SAN ANTONIO WATER SYSTEM
DISTRICT SPECIAL PROJECT (DSP)
WELL METER REPLACEMENT PROJECT

SAWS JOB NUMBER 12-6105

ADDENDUM NO. 1
August 2nd, 2013

DRAWING NO. 21 of 68

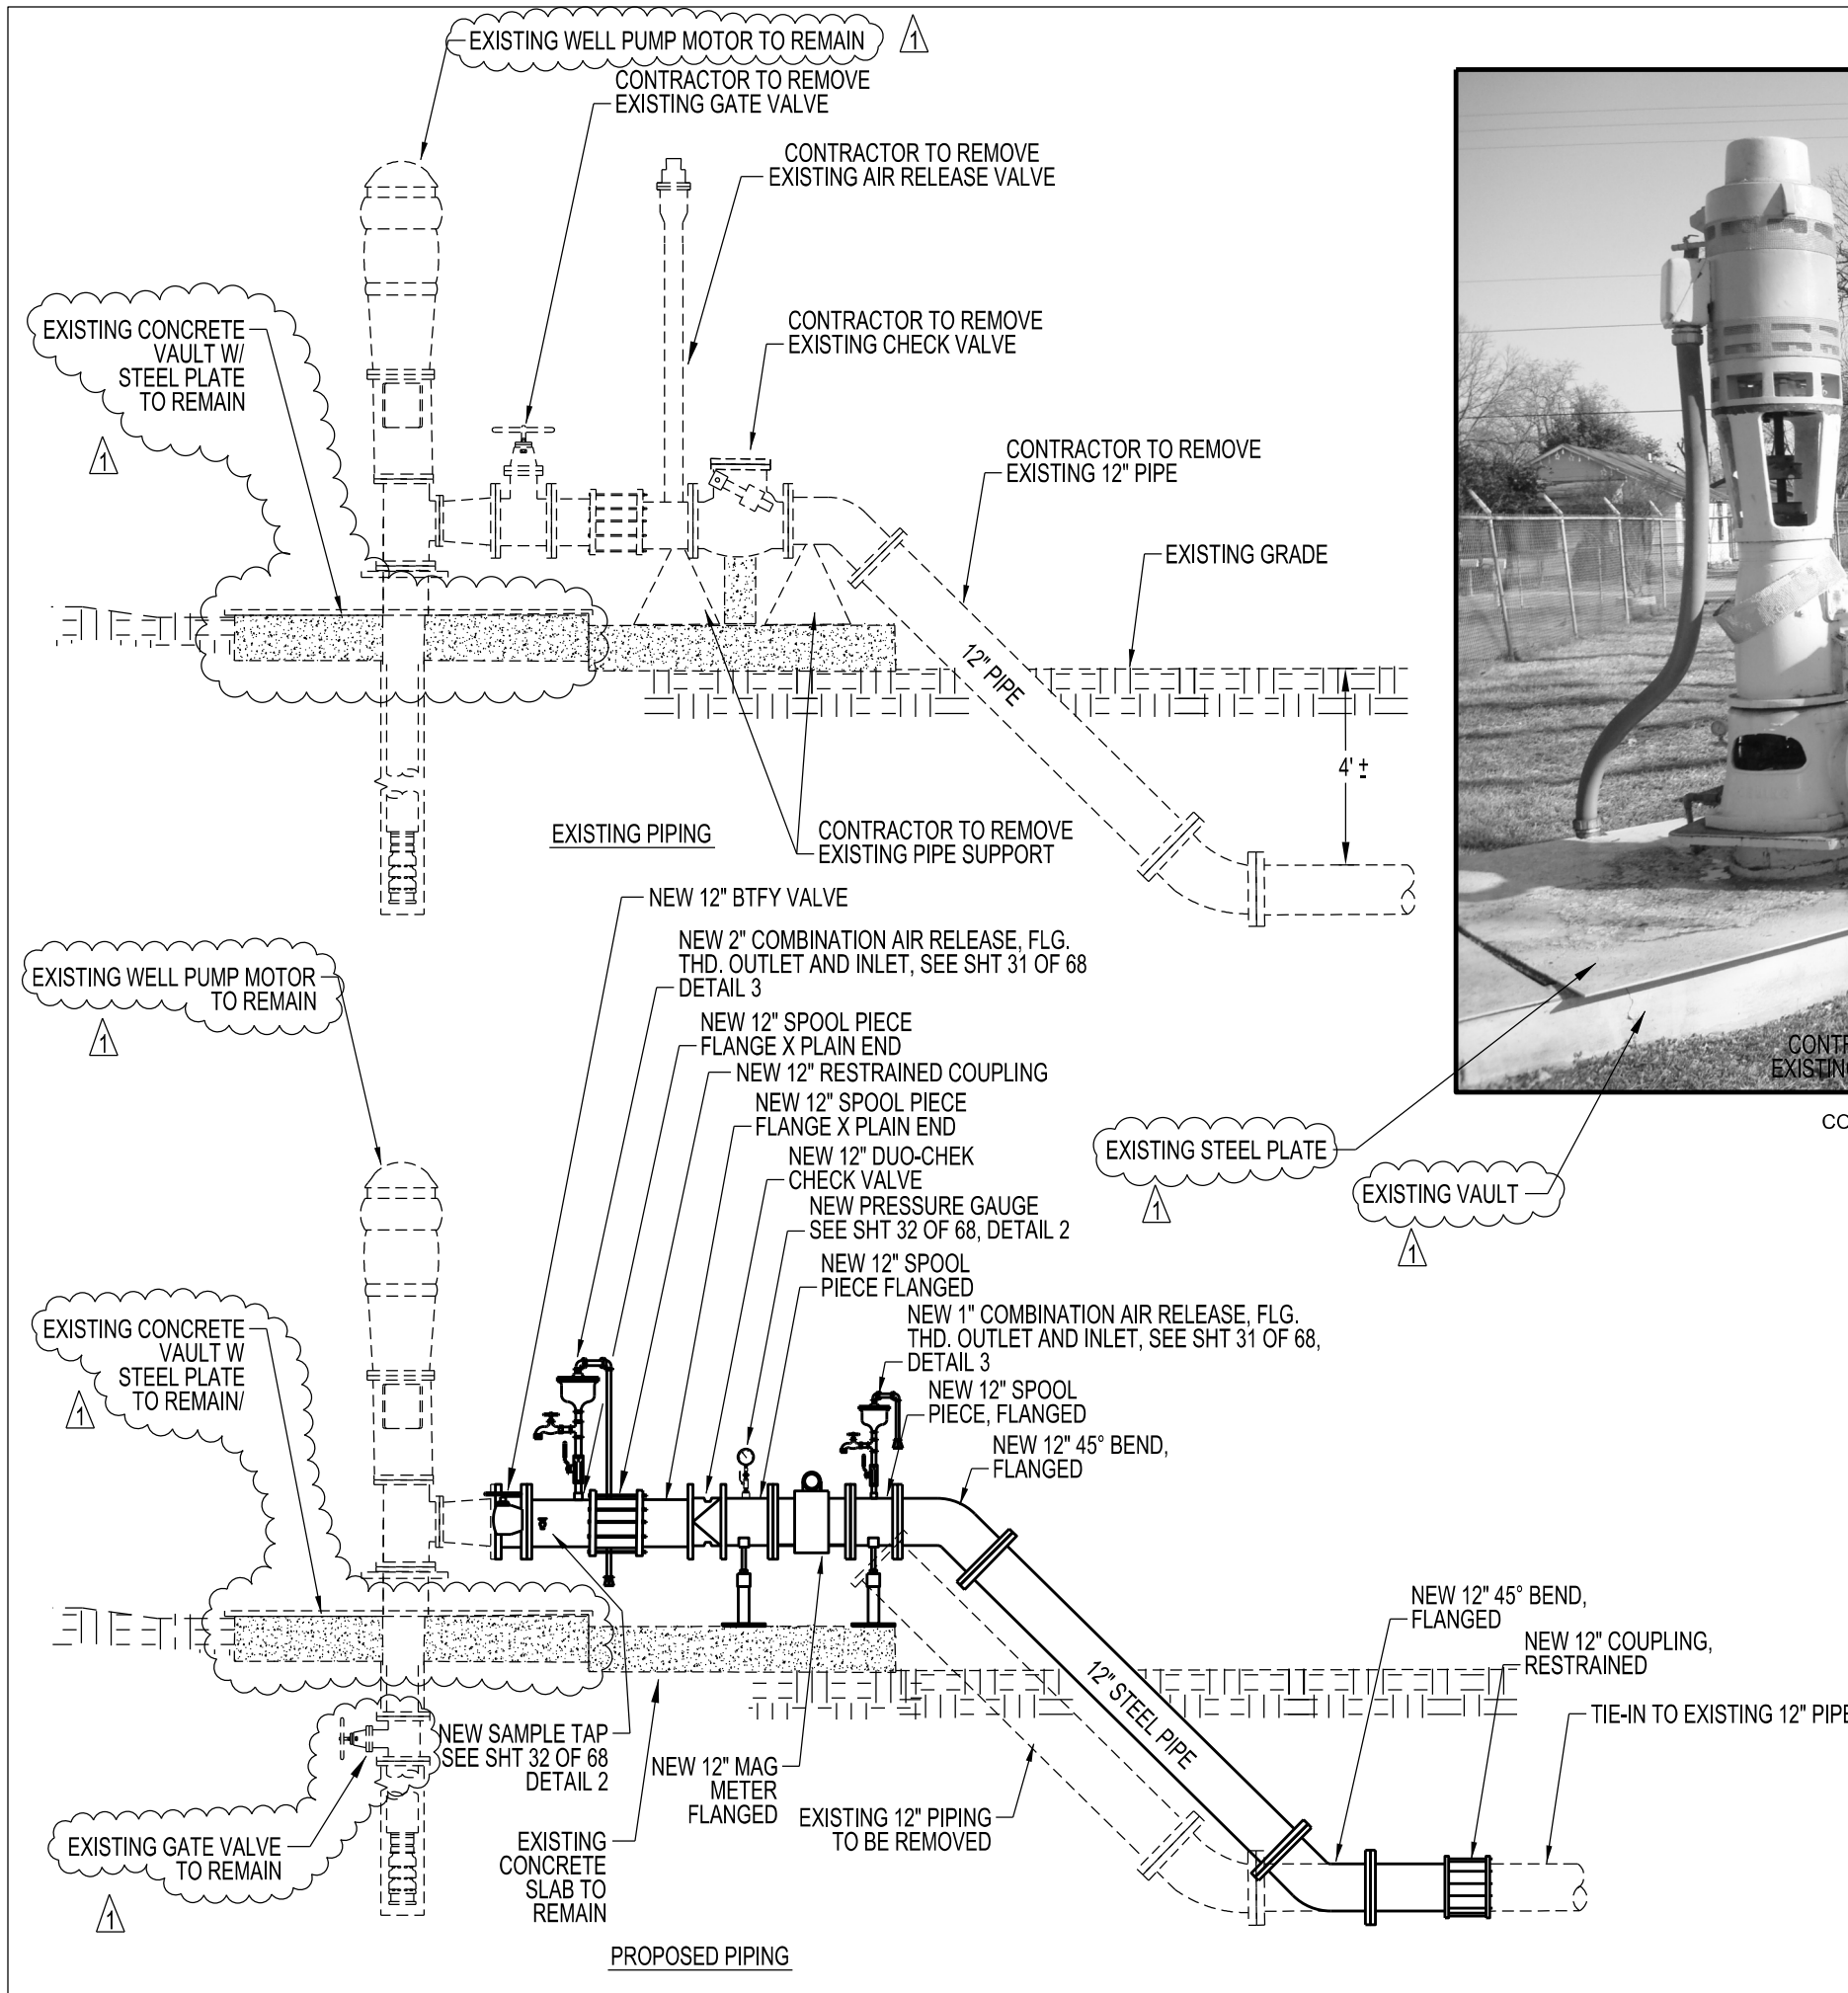
Sheet 21 of 68

Added Notes to Drawing:

Include improvements to adjacent above ground line that shall require additional pipeline to match to existing main.

See Exhibits A for plan sheet revision.
